Subject: UniStar Nuclear Energy, NRC Docket No. 52-016  
Response to Request for Additional Information for the  
Calvert Cliffs Nuclear Power Plant, Unit 3,  
RAI No. 264, Tornado Loads

**Response to  
RAI No. 264, Question 03.03.02-7,  
Calvert Cliffs Nuclear Power Plant Unit 3**

### **Question 03.03.02-7**

Figure 2.1-5— {CCNPP Unit 3 Enlargement}

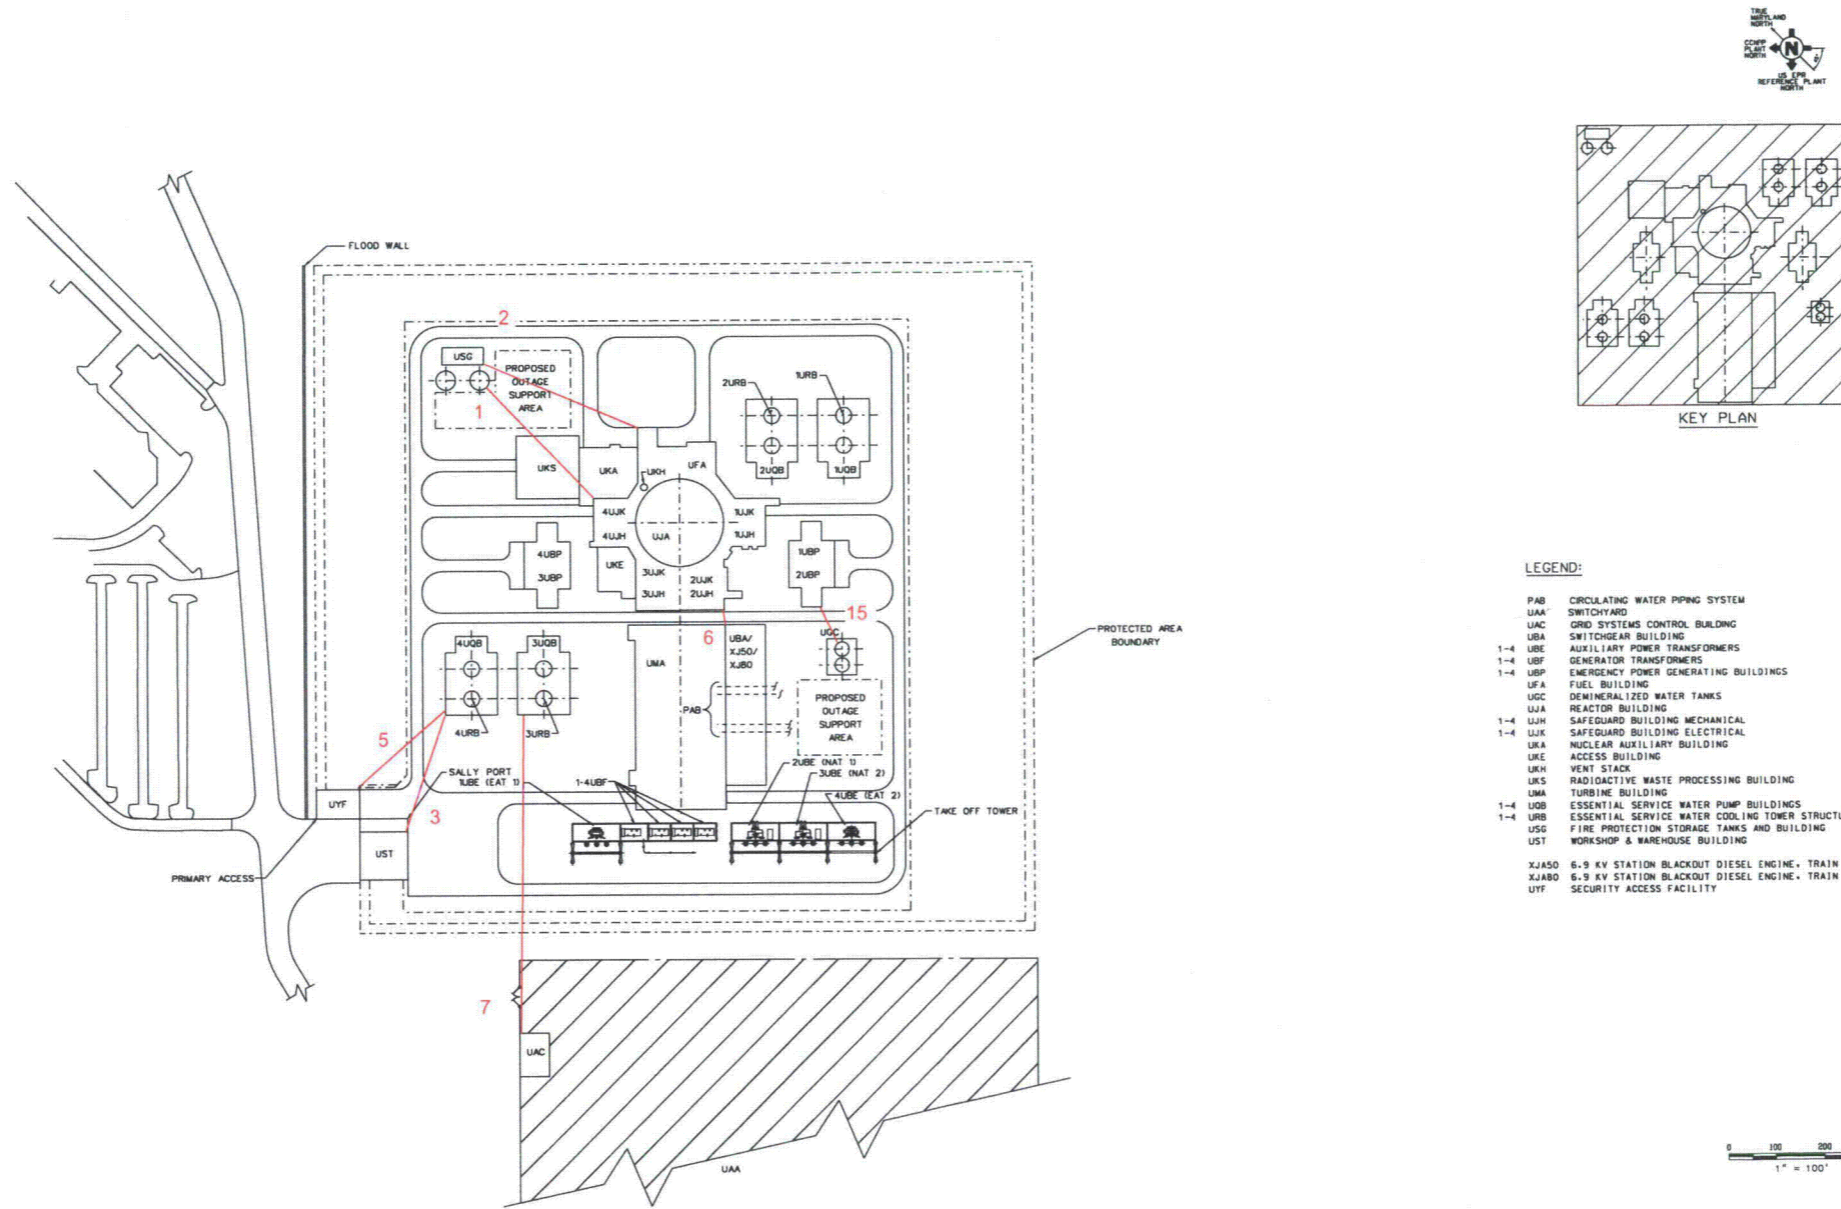
In response to RAI 128, Question 3.3.2-1, Part 1, regarding the separation distances between non-safety related structures and safety related structures, the applicant referenced Figures 2.4-2, 2.1-5, 2.4-51 and 9.2-4 and provided separation distances for the 13 structures listed in Table 1. Although the separation distances between the above mentioned structures in Table 1 are adequate, the staff is unable to verify this information from the referenced Figures due to lack of dimensioning and scale drawings. Further, the applicant noted in Figure 2.1-5 of FSAR, Rev.6, "Working with this drawing with 3-P1-0010-00001." The staff assumes this to mean there are other drawings with detailed separation distances. The staff could not find such drawings in the FSAR, Rev.6.

The staff requests that the applicant provide information on referenced drawing 3-P1-0010-00001 and other sources so the staff can verify the separation distances between the non-safety related and safety related structures listed in revised Section 3.3.2.3. The staff needs this information to verify the distances between aforementioned non-safety related structures not designed for tornado loadings, which could adversely affect the safety related structures in its proximity.

Enclosure 2 provides 11 x 17 enlargements of FSAR Figure 2.1-5, Figure 2.4-2, and Figure 9.2-4 from Revision 7. Because these figures are enlargements of the entire FSAR figure, the scale is included. This scale will allow the staff to confirm the separation distances previously provided.

Drawing 3-P1-00100-00001 was an internal reference to the source drawing for FSAR Figure 2.4-2. This note has been removed from FSAR Figure 2.1-5 in Revision 7.

To aid review, Table 1 from the response to RAI 128 Question 03.03.02-1, Part 1 (UN#09-378<sup>1</sup>) is reproduced in its entirety below. The Figure 2.1-5 and Figure 2.4-2 enlargements have lines added between the non safety-related structures and the nearest safety-related structures. The lines are identified by the item number listed in the left-hand column of the above table. These two figures show all listed structures except for Items 10 and 14, the Circulating Water System Makeup Water Intake Structure and the Forebay, which can be seen on Figure 9.2-4. The Forebay is included in this table although it has been re-classified as a safety-related structure. The non safety-related Circulating Water System Makeup Water Intake Structure is more than 50 feet from the Forebay. This can also be seen on Figure 9.2-4.
